ENCLOSURES:
Addl info regarding proposed changes to the Tech Specs & Bases for Nine Mile Point Station

NIAGARA MOHAWK POWER CORPORATION

Re: Docket No. 50-220
License DPR-17

We submit the additional information requested in your letter of March 21, 1972 regarding proposed changes to the Technical Specifications and Bases for the Nine Mile Point Nuclear Station. Since testing of the new relief valve set points requires deinerting and access to the drywell, we plan, subject to your approval, to make these changes and perform the necessary testing during the current station outage.

FIGURE 1-
NINE MILE POINT

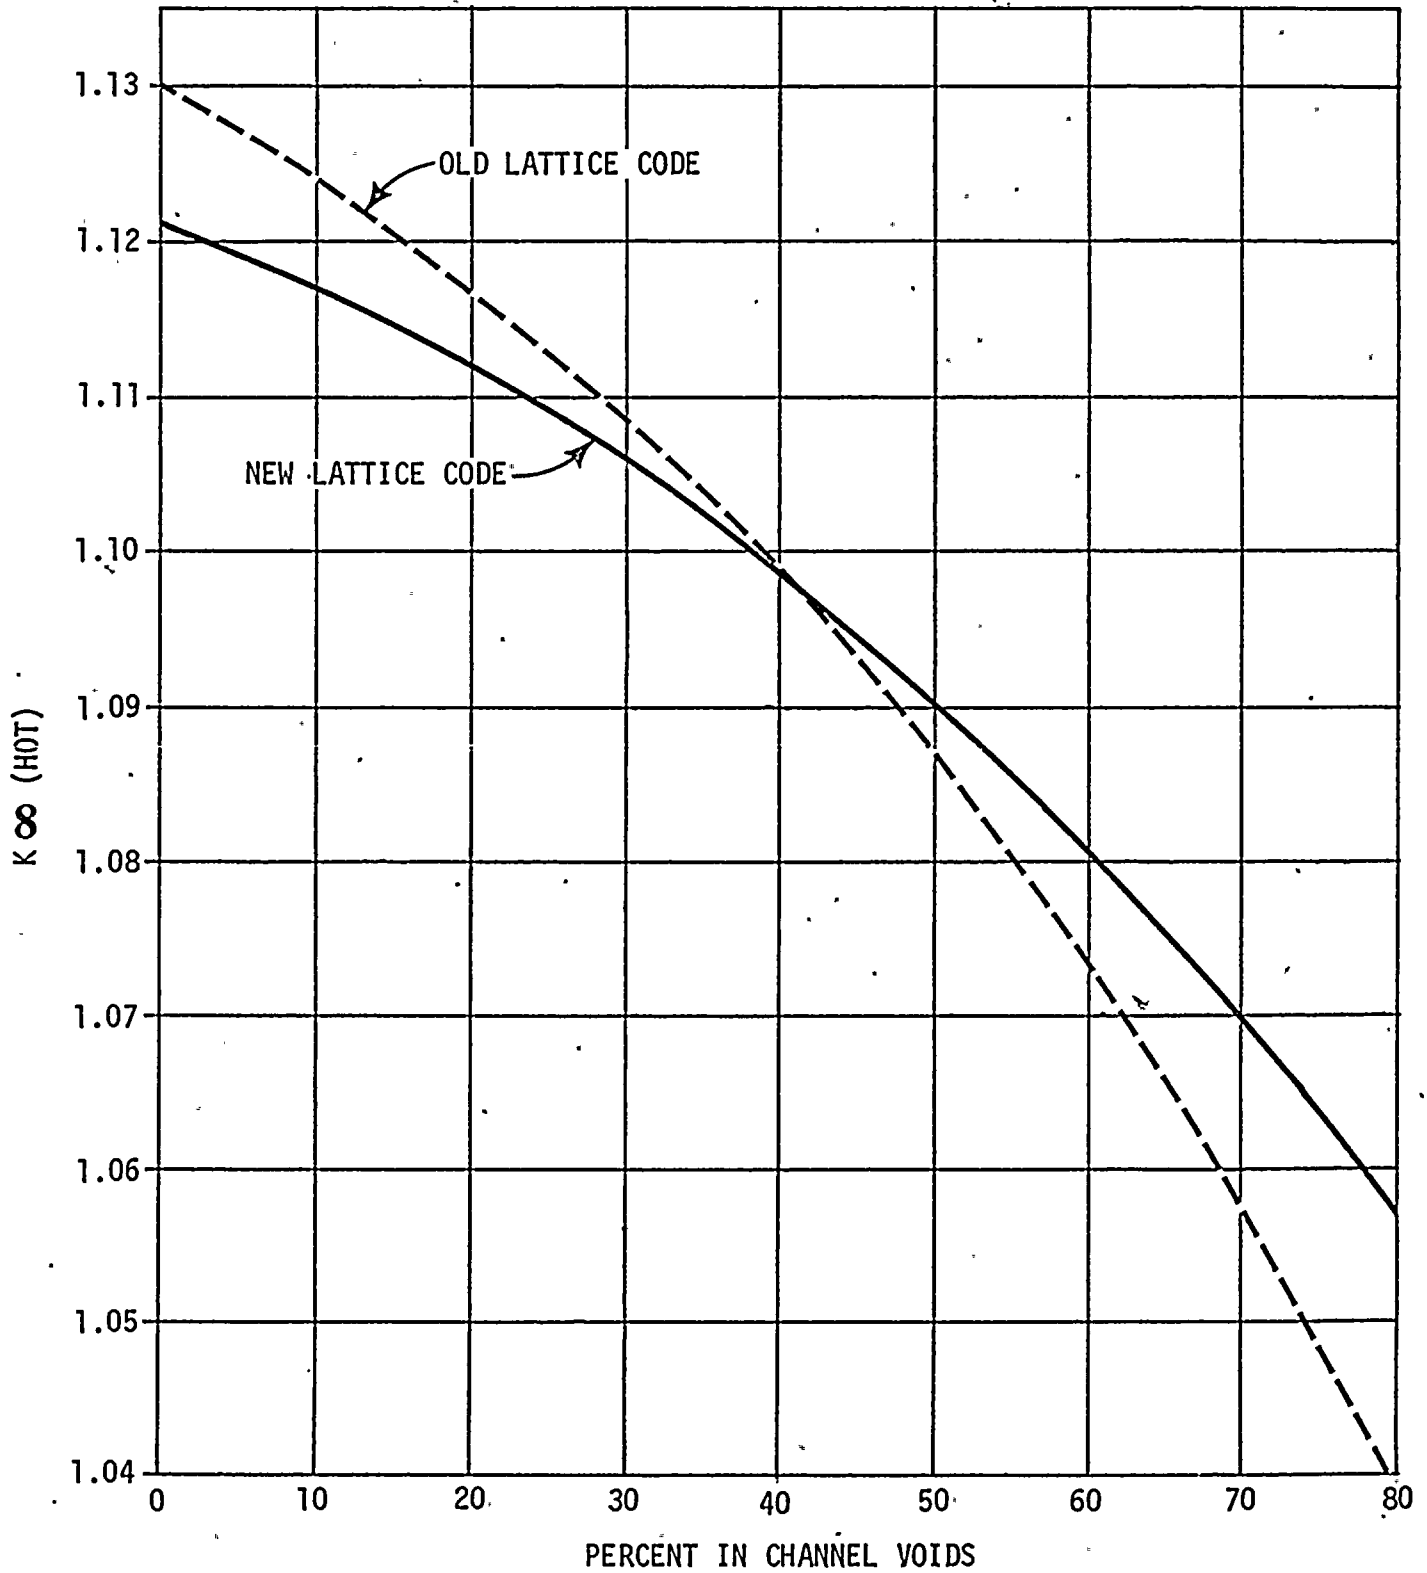
You state that improved analytical techniques available at General Electric Company caused you to adopt the proposed revised scram reactivity curve, but no information regarding these techniques was provided. Describe the analytical techniques used previously, the changes being made to the analytical model, and the basis for considering the change an improvement.

The newer lattice code results in an improved calculation of k^∞ 's. A significant difference in the k^∞ predicted by each lattice model can be seen by examination of the curves in Figure 1-1. The new lattice code predicts higher k^∞ 's at high void and lower k^∞ 's at lower void conditions relative to the older lattice code. This results in a lower predicted peak power at the bottom of the core which reduces the initial rate of scram reactivity.

FIGURE 2-1
NINE MILE POINT REACTOR
AXIAL EXPOSURE DISTRIBUTION

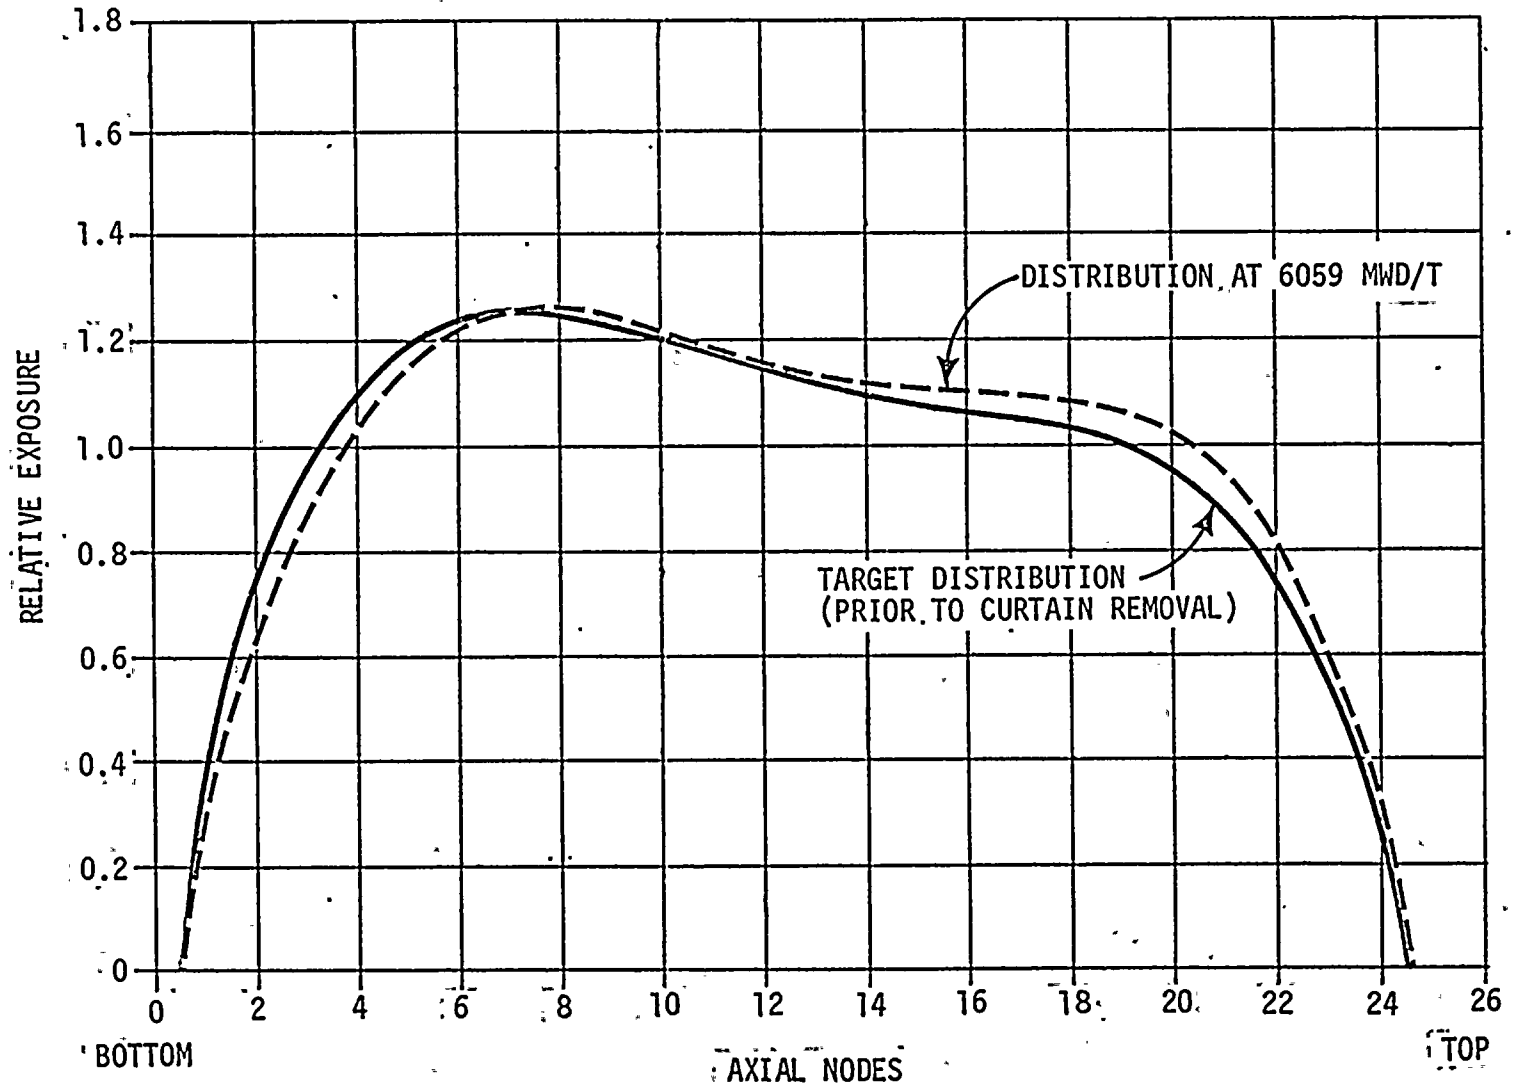
Describe the data and measurements obtained at Nine Mile Point from reactor operations and tests that support use of the new analytical techniques.

The management of control rod patterns at Nine Mile Point has enabled the core to develop and maintain an axial power distribution and, therefore, an exposure distribution, consistent with the objective of minimizing power peaking throughout each operating cycle. Figure 2-1 compares the exposure distribution calculated from Nine Mile Point reactor operation as of January, 1972, with the "target" exposure distribution derived from the Haling principle. The "target" exposure distribution has been computed for an all rods out condition prior to removal of control curtains, it does not represent the equilibrium end-of-cycle condition.

FIGURE 3-1

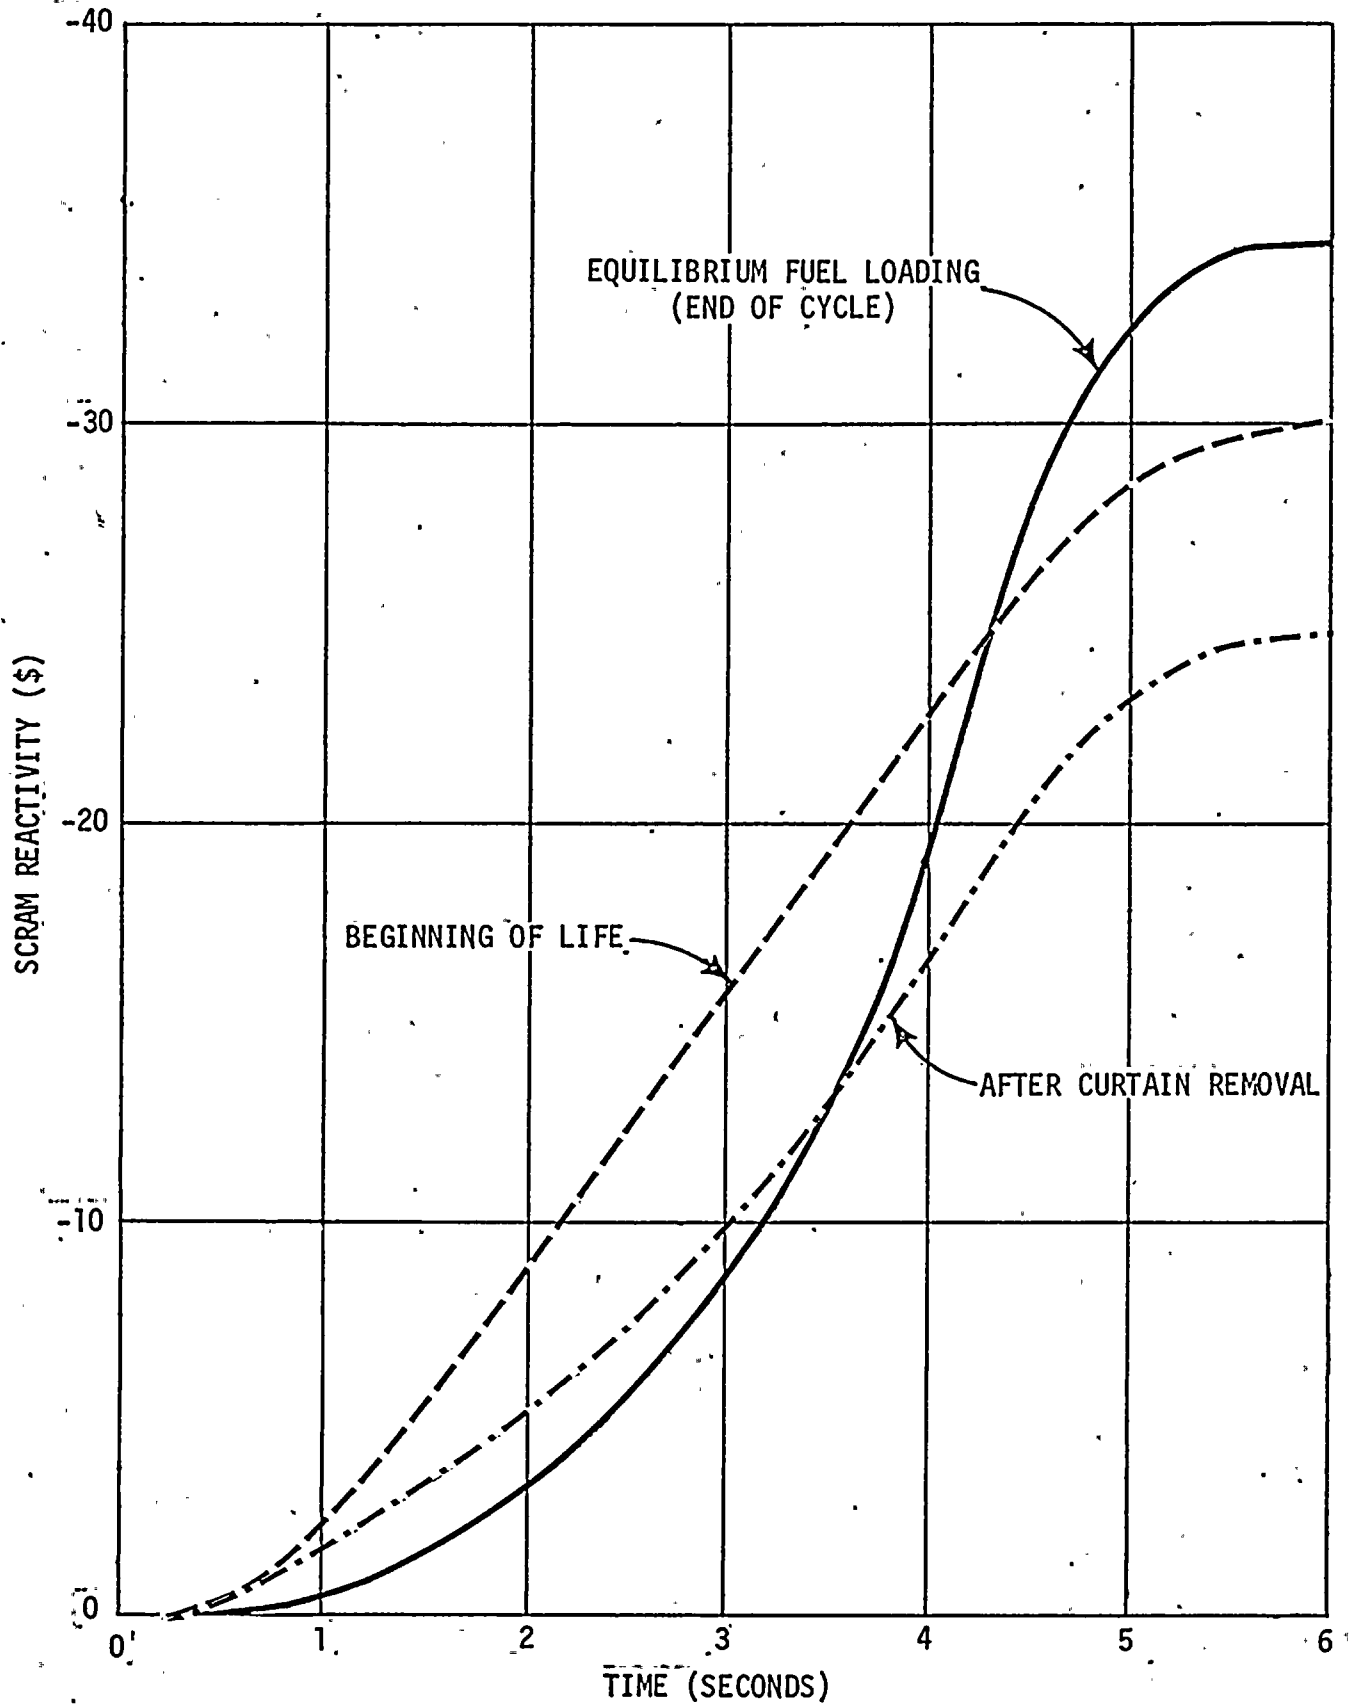
The effect of partial refuelings on the scram reactivity curve has not been presented. Please define the relationship of the present core loading with the scram reactivity curve and describe the effect on the scram reactivity from approaching an equilibrium fuel loading, including the expected operational control rod patterns.

Additional calculations have been made of a conservative scram reactivity curve typical of the period immediately following removal of control curtains. These results are shown in Figure 3-1 along with curves used in previous analyses. All of these scram reactivity curves are conservatively based on a scram time of 5 seconds for 90 percent insertion; a condition which does not exist at this station. Figure 3-1 indicates there will be a gradual reduction in the initial scram reactivity insertion rate as the core approaches an equilibrium condition. Figure 3-2 shows an axial control rod position and the resultant relative axial power distribution which is typical of expected reactor performance following the curtain removal.
